TECHNICAL BULLETIN

008

July 2014

Connecting rod screws p.n. 1801.01, 1801.05 and 1801.32

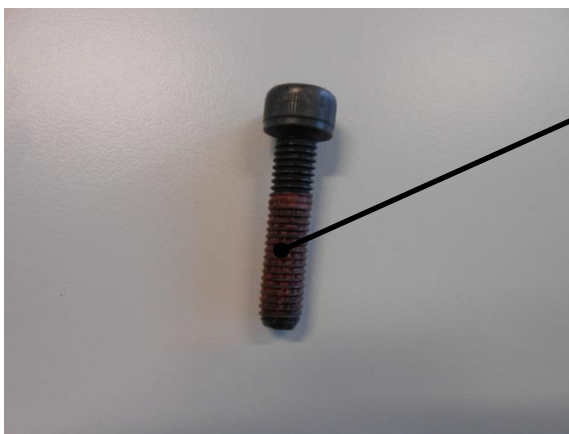
Locking
adhesive

The screws and nuts have been changed to avoid unscrewing under severe vibrations. The locking adhesive is dry-to-touch and it is activated during assembly and cures to form a tough polymer that eliminates movement between the threads and provides a total seal. The new screws are interchangeable with the old ones and all part numbers did not change.

Viti fissaggio bielle codici 1801.01, 1801.05 and 1801.32

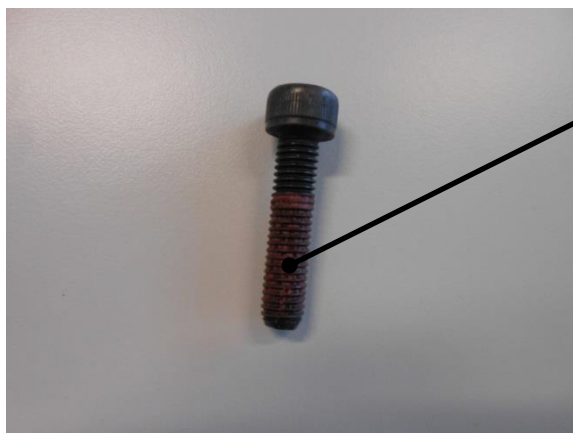
Adesivo
bloccante
preapplicato

Le viti fissaggio biella sono stati modificate per evitare svitamenti in presenza di forti vibrazioni.

L'adesivo bloccante preapplicato è formato da microcapsule che si frantumano in fase di assemblaggio rilasciando un attivatore che avvia il processo di polimerizzazione. Il prodotto polimerizzato si interpone tra le filettature riempiendo tutti gli interstizi bloccando e sigillando.

Le nuove viti sono intercambiabili e i codici non cambiano.
